Environmental Impact Assessment

Screening according to Schedule III of S.L. 549.46

ERA Reference no.: EA/00028/22

Project Title: Proposed garden centre including underground storage, visitor parking, open storage for trees, ancillary class 4D cafeteria and class 4B shop, and visitor's park.

Figure 3 – Proposed ground floor plan (Source: EApps doc PA/08500/21 – 85b)

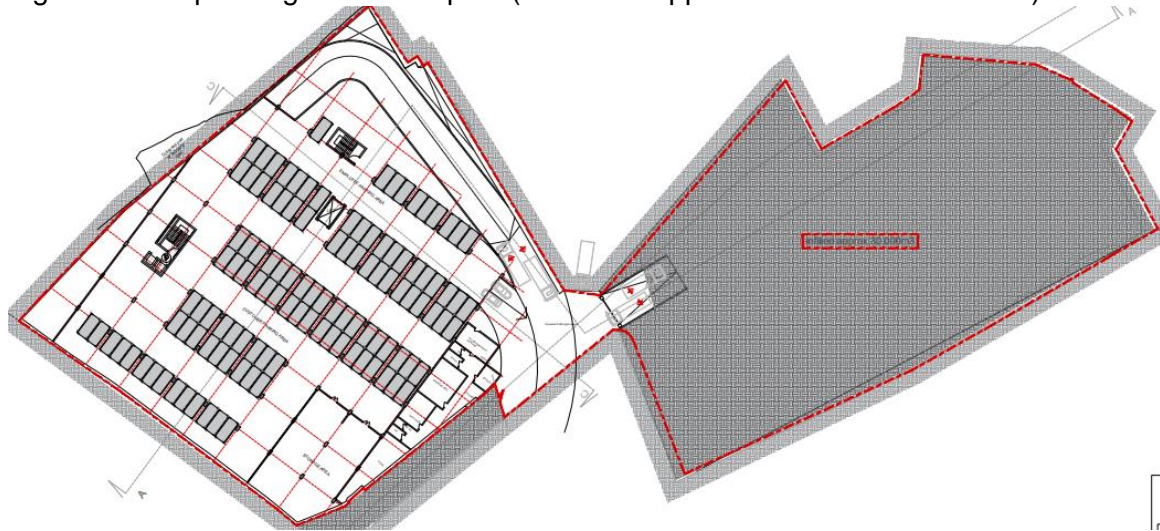
- Dog kennels in the eastern part of the site, with a maximum capacity for dog boarding services up to 64 animals (See Figure 3);
 - Installation of three reservoirs (with total capacity of 538 m³) for rainwater harvesting; and

- 6.2** In addition, in the eastern part of the site, dog kennels (with a max. capacity of 64 dogs) and an outdoor dog park are proposed for dog boarding services. The introduction of such kennels *per se* is not considered to be in conflict with the surrounding area, and the dog park is limited to soil cover. However, ERA requires that spread of built structures is minimised, hence the kennel structures is to be shifted closer to the garden centre, aligned with the site boundaries, to retain the eastern part of the site predominantly open with soil cover and trees/vegetation (landscaping/nursery). Hence, no significant impacts on land use are envisaged, subject that the above is adequately addressed.

- The relevant plans are to be amended to shift the proposed kennels closer to the garden centre, aligned with the site boundaries, to reduce spread of built development and retain the eastern part of the site predominantly open with soil cover and trees/vegetation (landscaping and nursery); and
- Further information is to be provided in terms of passenger vehicle trips to be generated by the development during operations, as compared to the existing situation on site (in AADT values – Annual Average Daily Traffic).
